TRANSMITTAL

Job: 16158 — Sweet Home City Hall

Re: **Change Proposals**

1 FLOOR PLAN
1/8" = 1'-0"

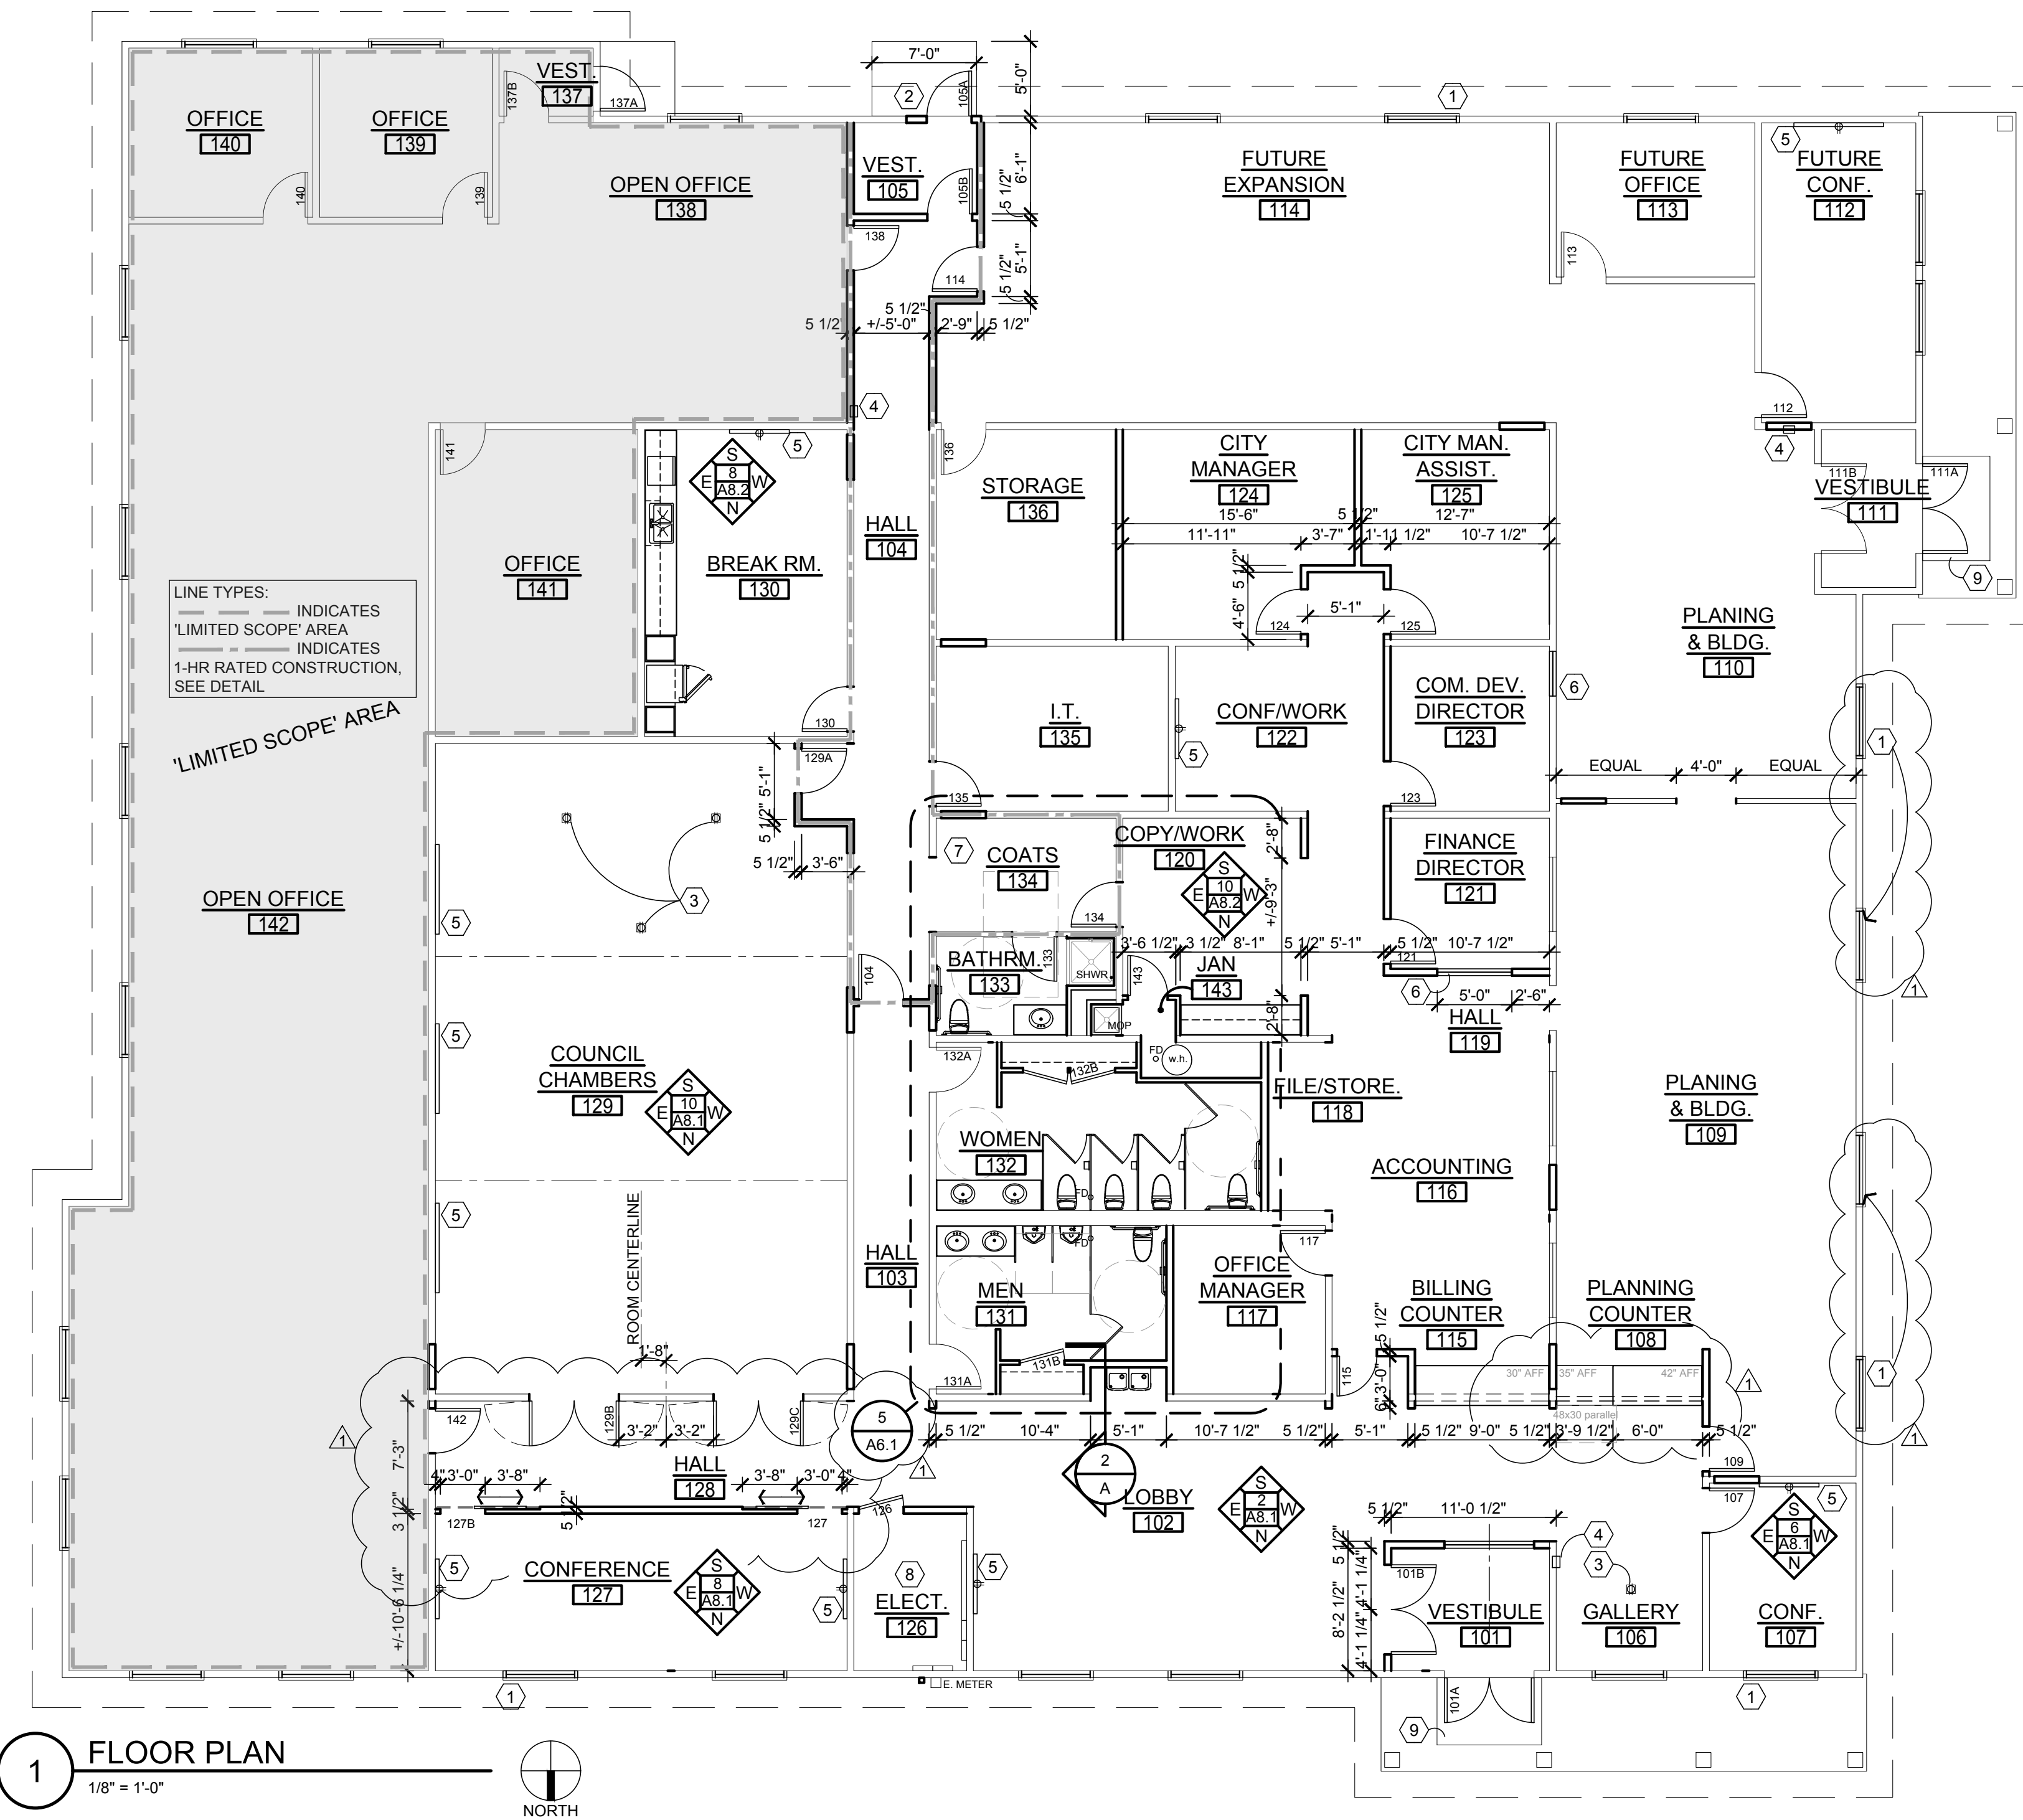
1. Enlarged Plan reference Change enlarged toilet area reference from 5/A7.1 to 5/A6.1
2. Toilet Room Expansion Expand toilet room 'Men 131' and 'Women 132' to include (1) additional fixture each room per attached 1/A2.1, 5/A6.1 2&4/A8.2
3. Toilet Room designations Change directional indication of Toilet Rooms on sheet A8.2 per attached sheet A8.2. (North, South...)
4. Rod and Shelf Change keynote 7 per attached 1/A2.1

1. Provide a second door to 'Conference 127' (Door 127B) per attached 1/A2.1
2. Change door 127 and 127B to a sliding "barn-door" style door and hardware similar to attached sketch CP1-2.
3. Doors to be - 3'-6" wide x 7'-0" high - double-side (all sides / edges finished)
4. Modify the position of adjacent doors as indicated to provide appropriate clearance.

1. In lieu of the two windows identified for replacement in 'Planning & Bldg 109' (keynote '1'), replace the other two (center two) per attached 1/A2.1
2. Provide unit pricing for replacement of additional existing windows with new, operable units. (Cost per window)

1. Modify height and configuration of 'Planning Counter 108' to 35" and 42" a.f.f. per attached drawings 1/A2.1; 17, 18 & 22/A7.1
2. Replace sliding glass system with drop-down security shutter at 'Planning Counter 108' per attached drawing 2/A8.1
3. Modify soffit at 'Planning Counter 108' per attached drawings 1/A2.3

2 SOLATUBE SOFFIT DETAIL
 1 1/2" = 1'-0"

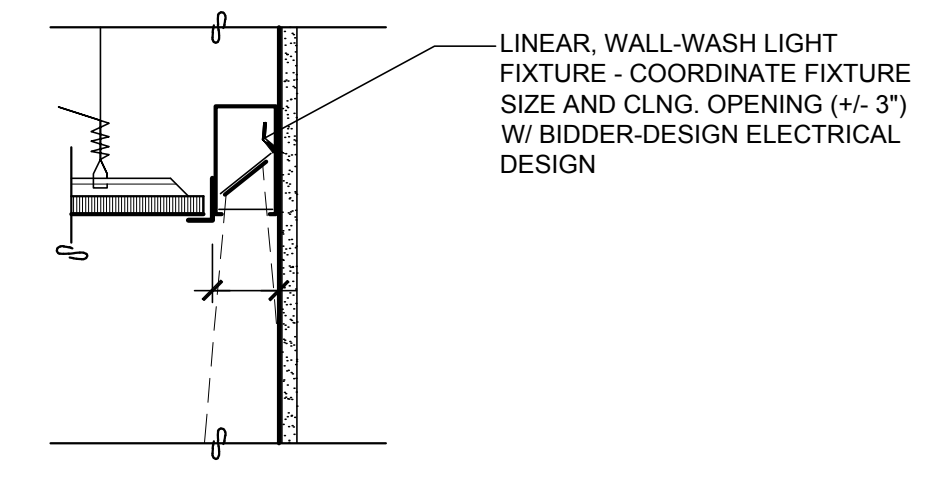
- a. Please provide a cost-per-unit for additional units to match detail 2/A7.01
- b. Please provide a cost-per-unit for additional units without the GWB soffit. Provide standard trim-ring for ACT installation.
